Fig-3

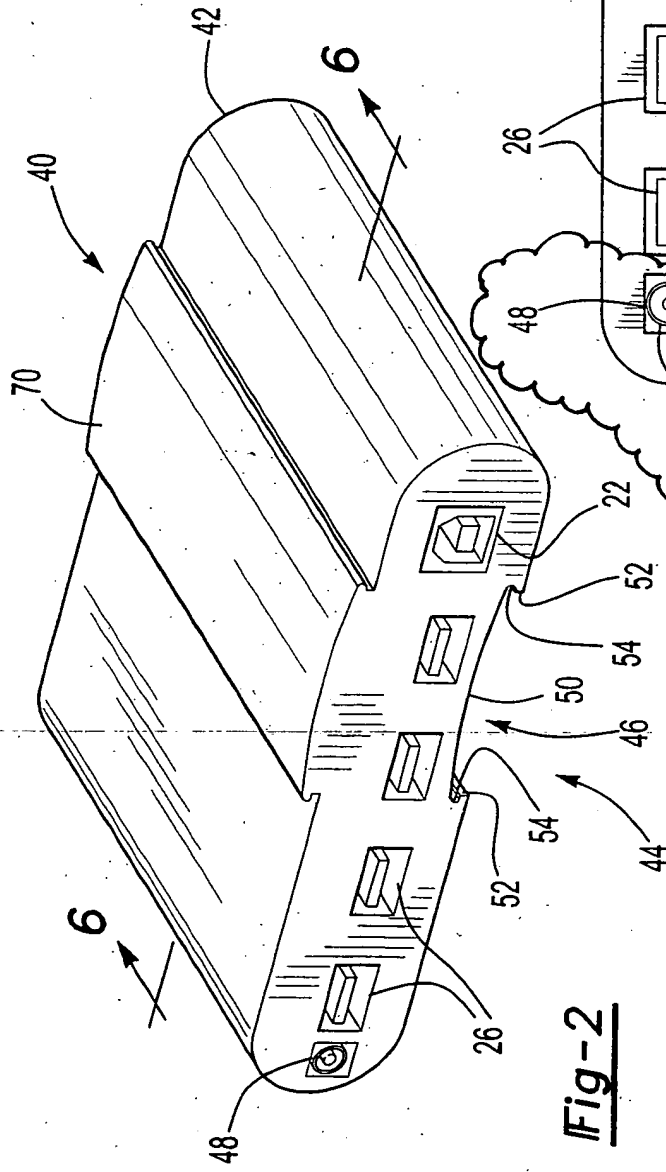
The Examiner indicated that the drawings filed on April 30, 2001 are objected to because reference numerals 48, 48a and 48b; 101, 117a and 117b; 118, 118a and 118b are not found on the figures. Also, reference number 314 on Fig. 32 is not found in the specification. Further, pins D and G are not labeled in Fig. 33. The Examiner requested proposed drawing corrections or corrected formal drawings in reply to the office action.

Applicant has amended Fig. 3 to depict reference numbers 48, 48a and 48b as described on page 11 of the specification. Applicant has amended Fig. 14 to depict reference numbers 101, 117a and 117b as described on page 14 of the specification. Applicant has amended Fig. 11 to depict reference numbers 118, 118a and 118b as described on page 15 of the specification. Reference number 314 on Fig. 32 has been deleted. Fig. 33 has been amended to depict pins D and G as described on pages 22-24 of the specification. Informal drawing sheets having the above amendments highlighted in red ink according to MPEP § 608.02(v) are included herewith. No new matter has been entered as a result of these amendments.

FIG. 27

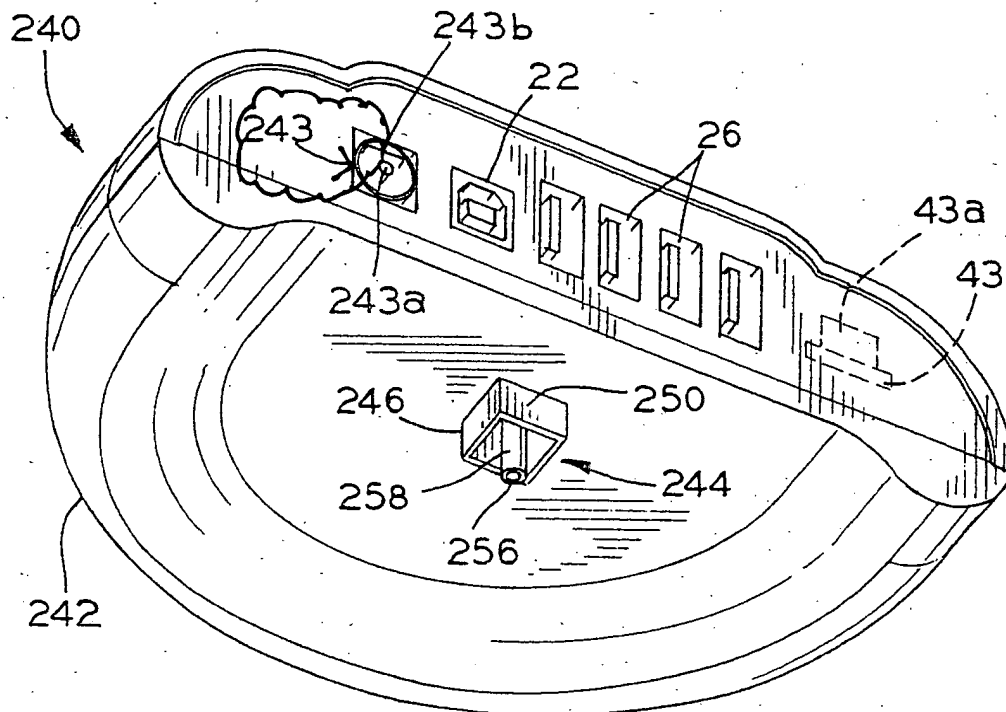
Applicant noticed the following items which also require correction. Applicant has also added reference number 80 to Fig. 14 as supported in the specification. An arrow has been added to the leader line for reference number 243 on Fig. 27. Fig. 32 has been amended to more accurately depict a preferred embodiment of applicant's invention. Informal drawing sheets having the above amendments in red ink are included herewith. No new matter has been entered as a result of these amendments.
